Zoning Staff Report

Case Number: ZC-25-029

Zoning Map Amendment & Site Plan

28TH ST FRANCHISE HOTEL

SITE PLAN

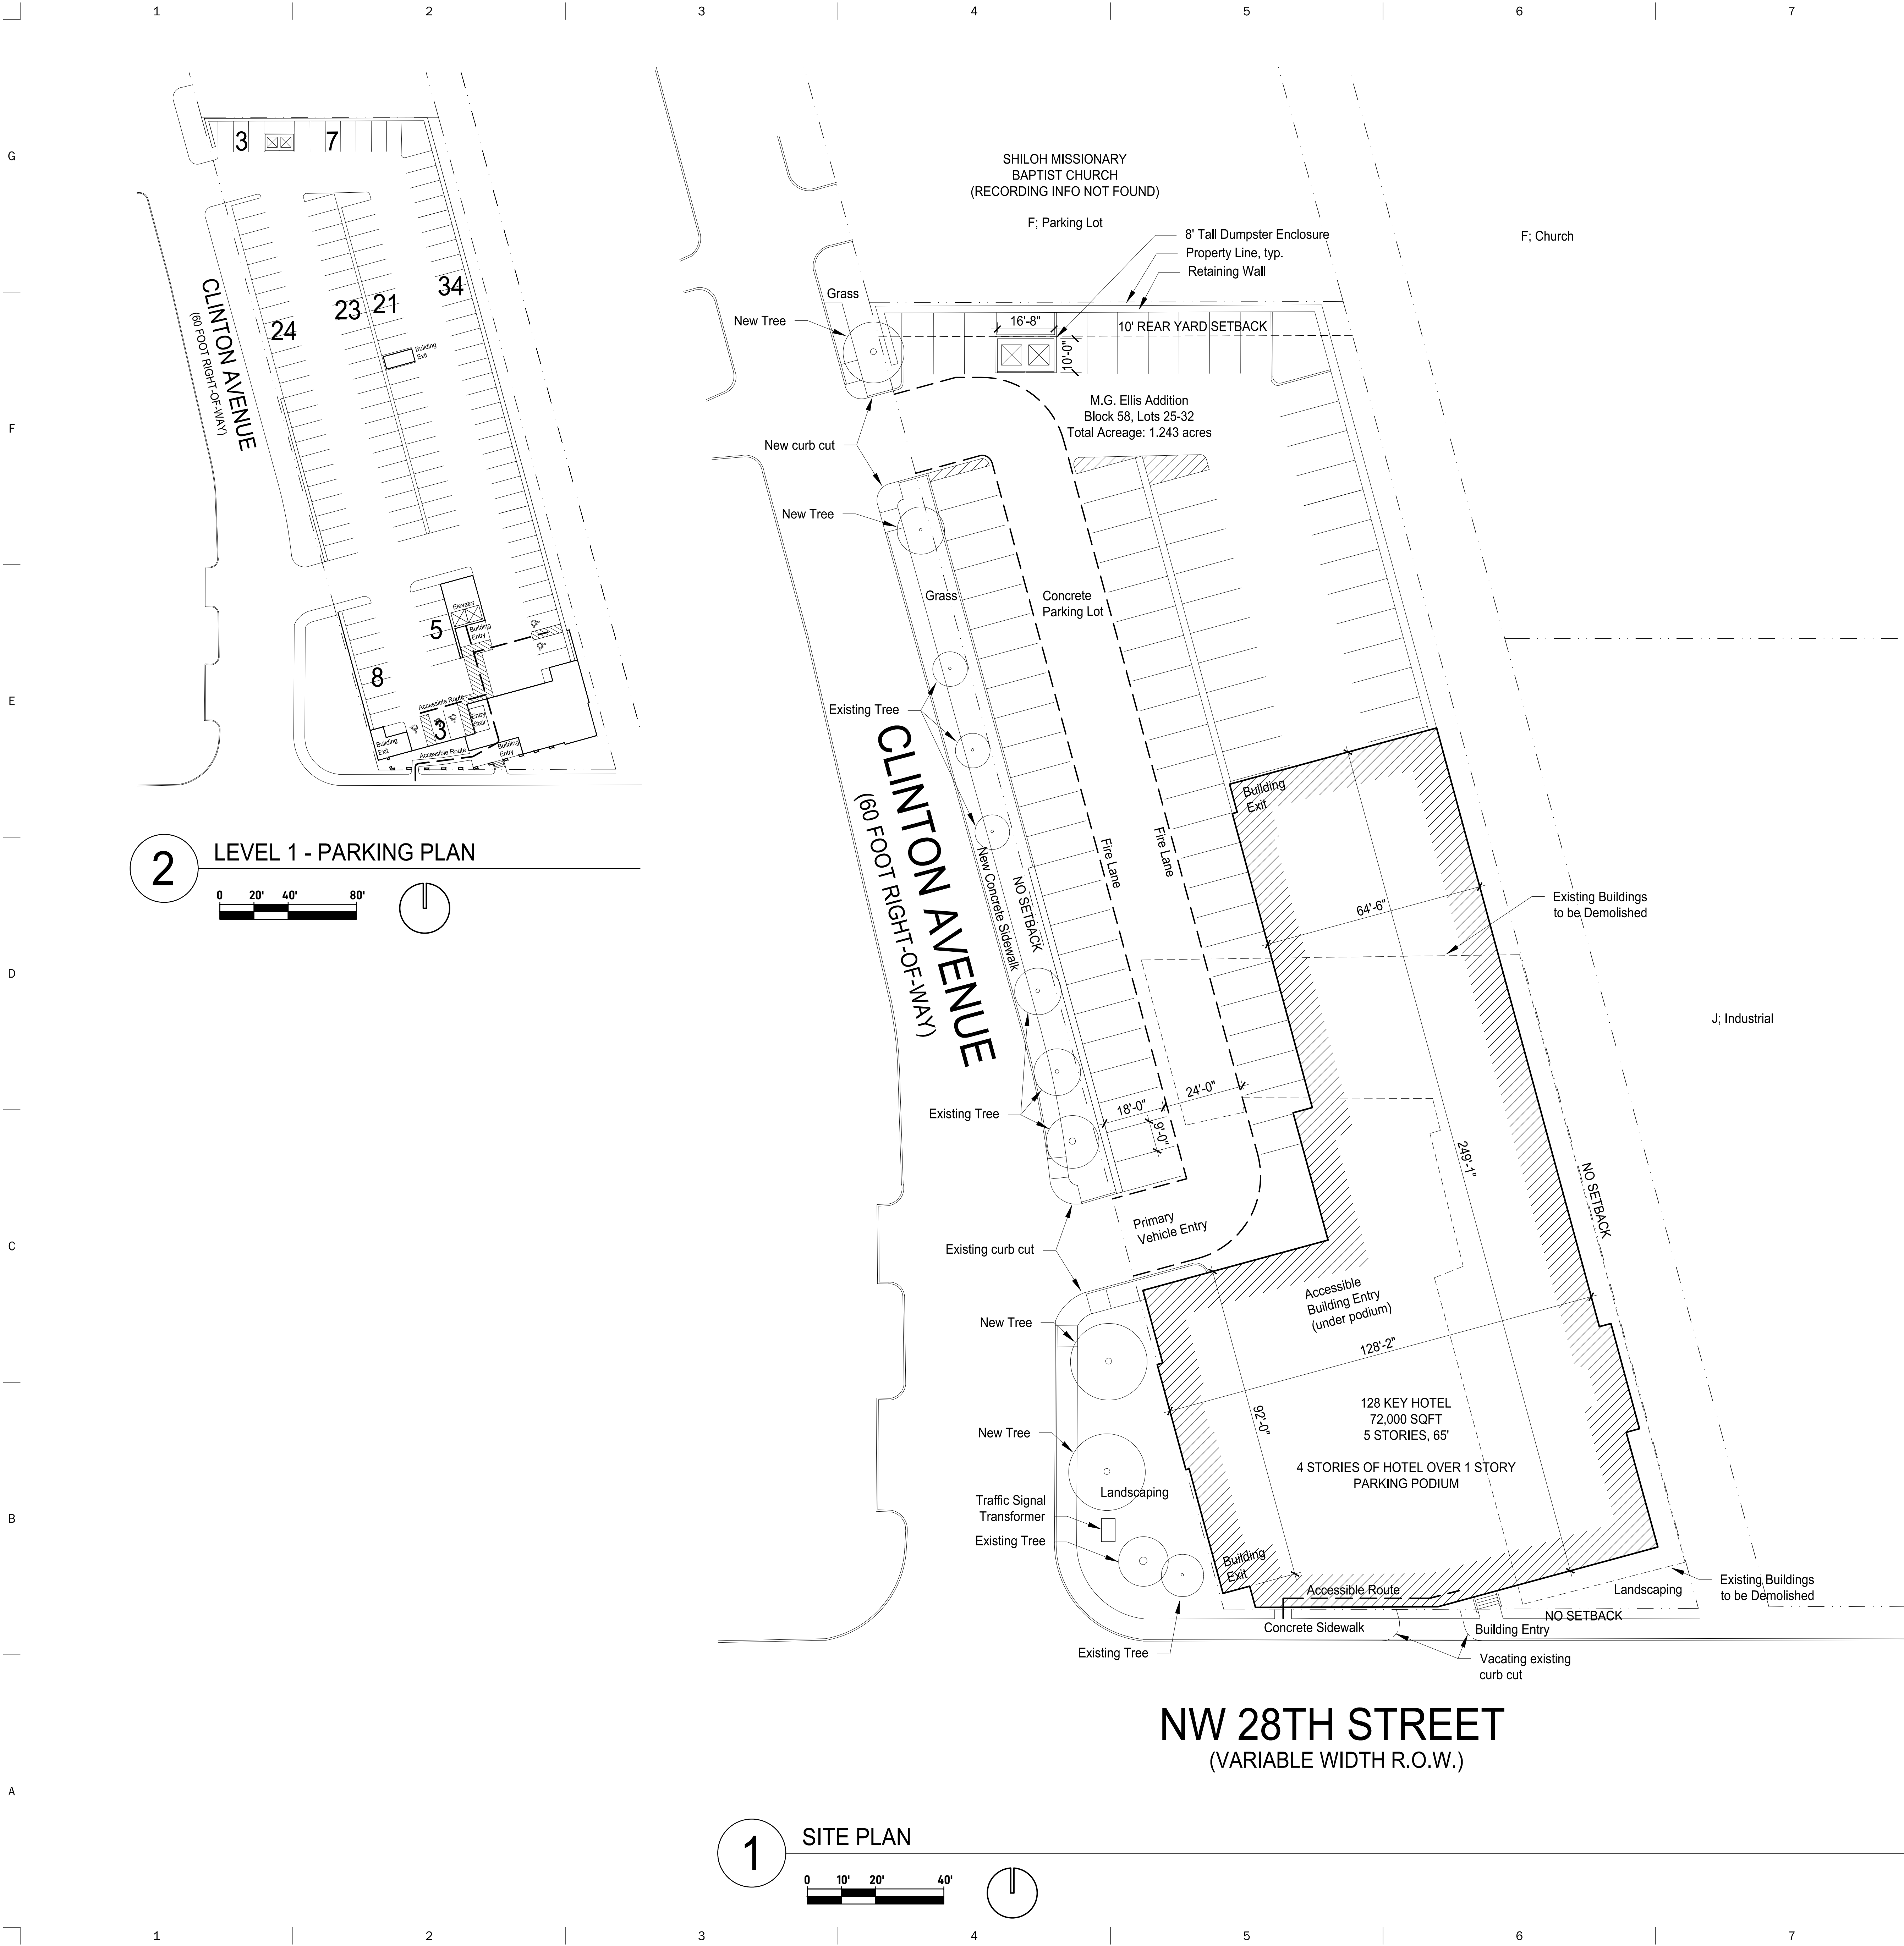
The site plan complies with proposed plan development PD/FR with the development waivers. As well as the zoning regulations for Site plan submissions for planned developments outlined in Ordinance 4.301.b (‘*Site Plan Requirements*’).

- Driveways are subject to Access Management Policy spacing requirements where TxDOT's do not - 250 feet of spacing required from intersections and other driveways, 75 feet on Clinton Ave. **Site plan appears to be in compliance on Clinton. TDS supports sole access to site on Clinton instead of NW 28th.**
- NW 28th is a TxDOT road. You will want to check in with them regarding ROW width needs, if any.
- Sidewalks will likely need to be expanded to 10 feet wide along NW 28th
- Sidewalks on Clinton must be 5 feet wide or 6 feet if back of curb.
- Project may require a Traffic Impact Analysis prior to building permit approval.
